Product / Process Change Notification (PCN)

PCN #: PCN_ConMJ_20230508

Affected Series: WR-MJ;
 615008145121
 615008145221

Before Change	After Change
615008145121 	615008145121

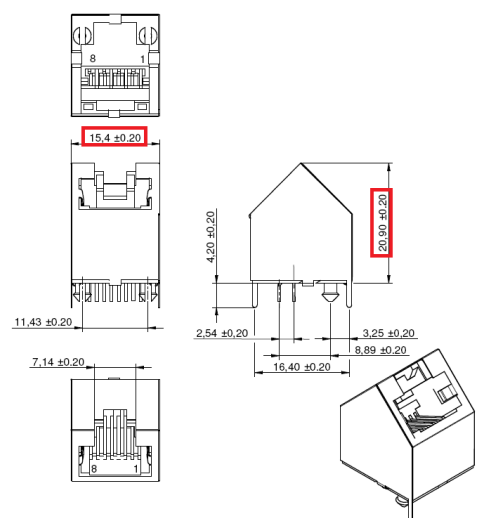
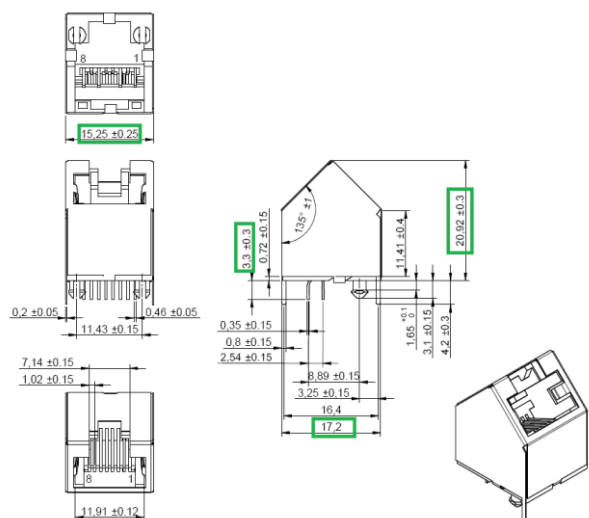
As a datasheet information amendment, Würth Elektronik is correcting the dimensions on the datasheet. This is a datasheet correction only. There will be no change in form, fit, function, quality or reliability of the product.

615008145221

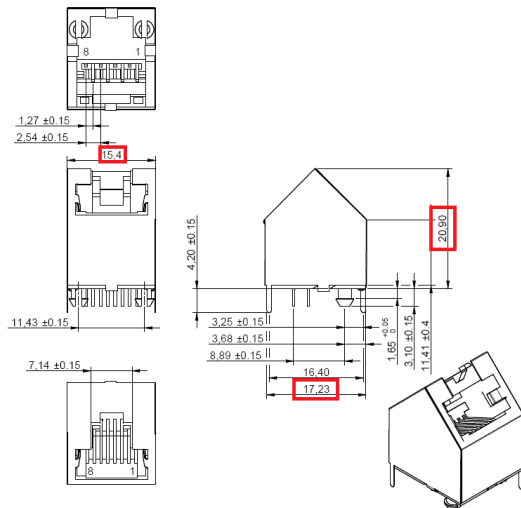
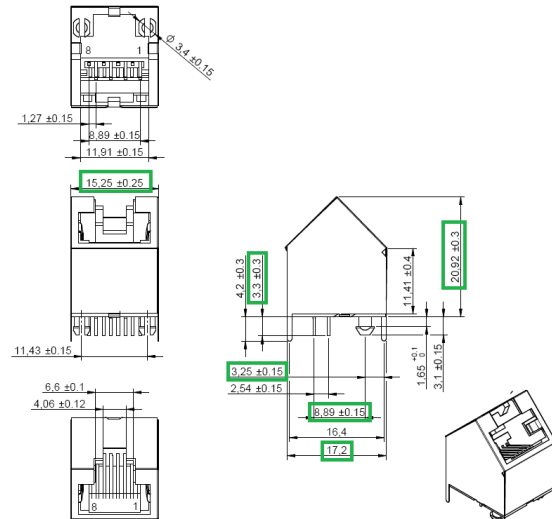
Some tolerances have been adjusted to better reflect the reality of the production line and testing.
